POWERTECH (USA) INC.

Response: TR RAI-2.5-5(a) and (b)

**TR Appendix 2.5-D
“Meteorological Characterization of the Dewey-Burdock Uranium Project Area”**

**METEOROLOGICAL CHARACTERIZATION OF THE
DEWEY-BURDOCK URANIUM PROJECT AREA
FALL RIVER AND CUSTER COUNTIES, SOUTH DAKOTA**

Figure 2.7-11 Dewey Well Field #1 Drainage Detail

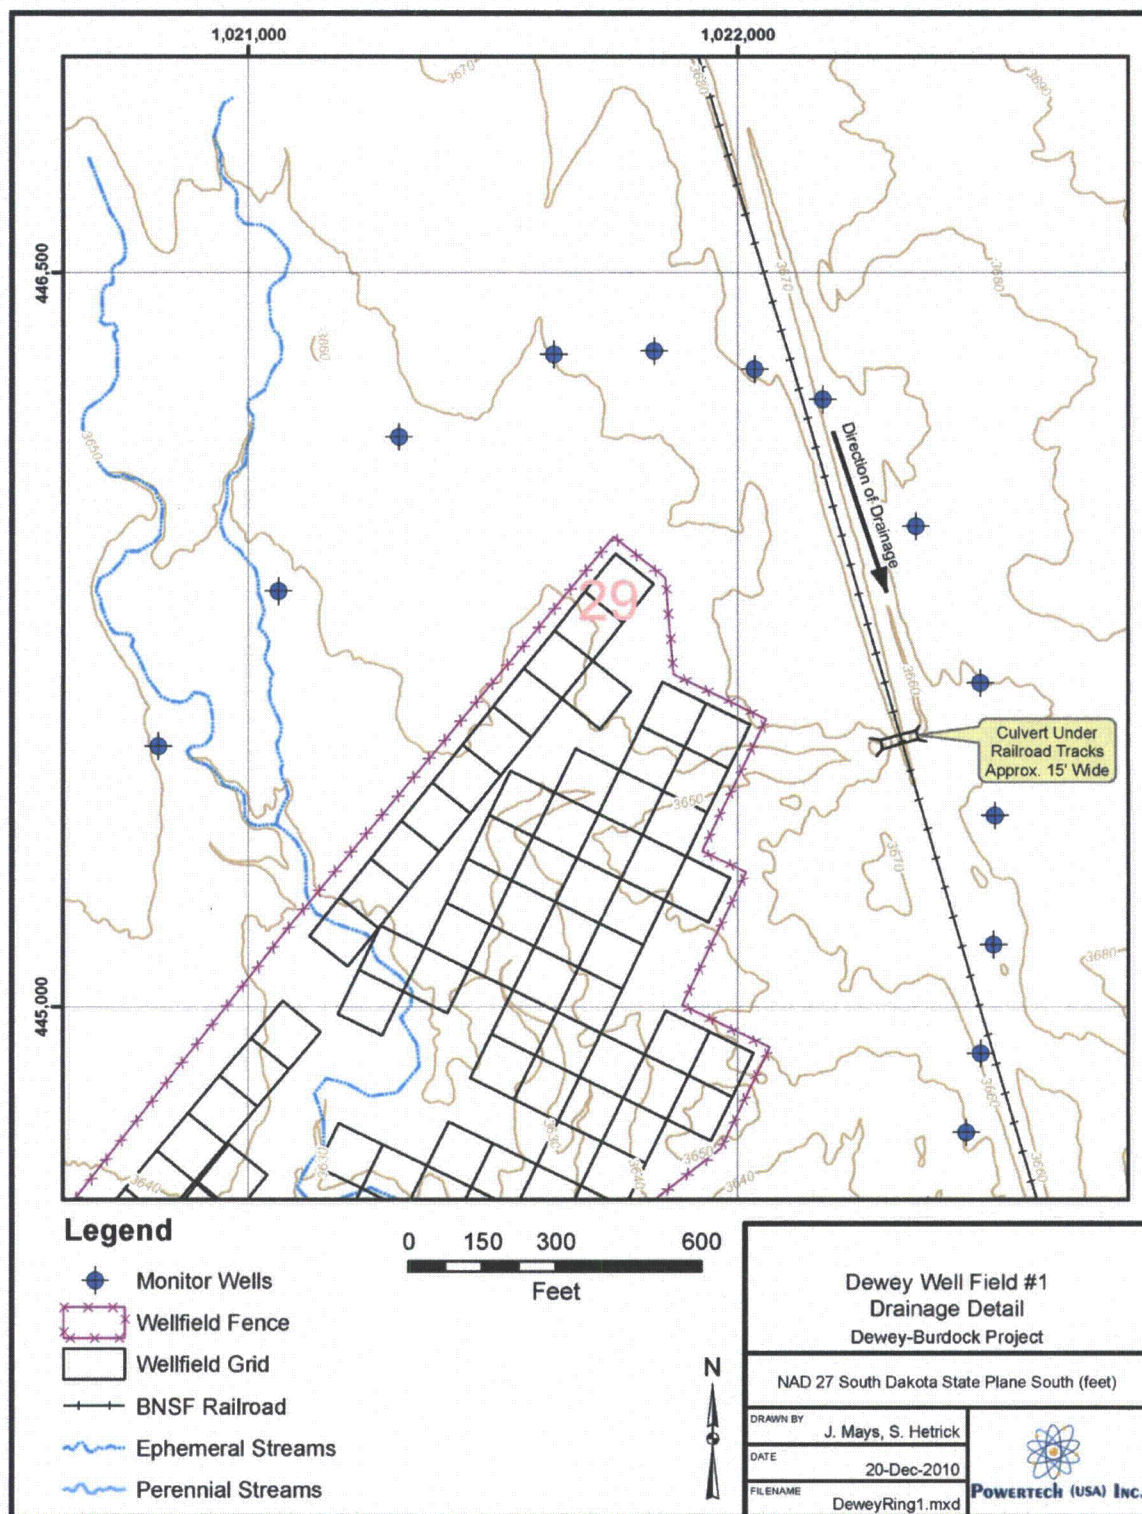
Staff is uncertain if standing water in poorly drained areas will hamper access to wells and potentially facilitate well leakage. Please clarify the surface drainage of this area.

In Section 29, T6S, R1E, a small number of monitoring wells are proposed on the northeast side of the tracks (Exhibit 3.2-1 of the TR). The surface drainage in this area is still dominantly toward the southwest (Figure 2.7-12 below), but the raised track beds do provide some potential for standing water. The potential for collection of water is predominantly immediately adjacent to the north east side of a raised-bed for the railroad tracks. Standing water is not expected in the location of any of the monitor wells as the area is well drained in a south easterly direction along the tracks and to a culvert in the immediate vicinity.
